GUIDANCE NOTE 08/2017 (Rev 1.0)

MARIOFF HI-FOG SAFETY BULLETIN

Number 004/2017

**HI-FOG® 1900 SPRINKLER
WITH
A1000 TYPE ASSEMBLY BODY WITH STOP VALVE
IDENTIFICATION AND CORRECTION PROCEDURE**

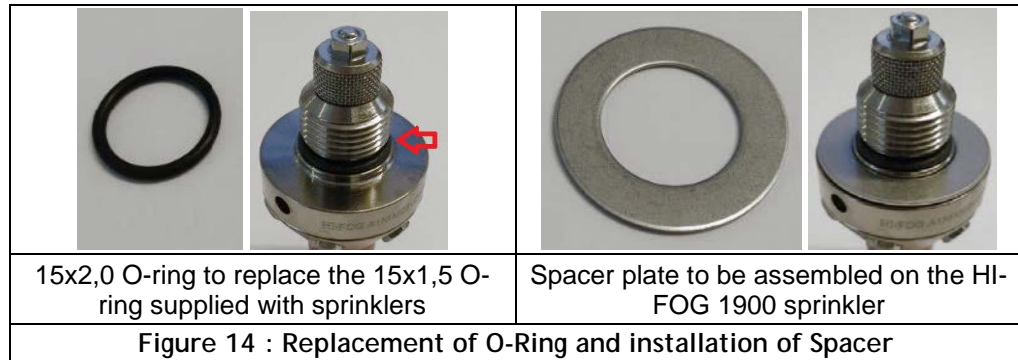
If the type is A1000 then verify from the inside of the assembly body if there is an internal stop valve (see Figure 13).

If there is **NO** internal stop valve, reinstall the sprinkler (go to step **g** below).
If the type is A1000 AND there IS an internal stop valve then continue:

- e. Remove the 15x1,5 O-ring from the sprinkler (see Figure 14). Do not damage or scratch the sprinkler's sealing surface. Cut the removed O-Ring to assure it does not mix with the new seals.

- f. Install the new 15x2,0 O-ring to the sprinkler by placing the O-ring installation cone (see Figure 05) over the spindle and rolling the new O-ring onto the sprinkler until you are sure the O-ring sits correctly in its groove (see Figure 14).
- g. Install the spacer to the sprinkler (see Figure 14).
